TENSIONING ARM 56653

IMPROVED MARKINGS

TECHNICAL INFO NO. 1118

Image 3: Left, old version with wide attachment points.

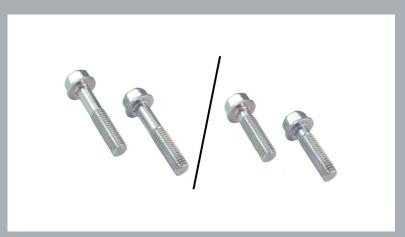
In addition, the attachment points for the new version are 10 mm narrower compared to the old points. In the modified version, the width of the attachment points is 12 mm (image 3, right); in the old version, this was 22 mm (image 3, left).

Right, new version with narrow attachment points.
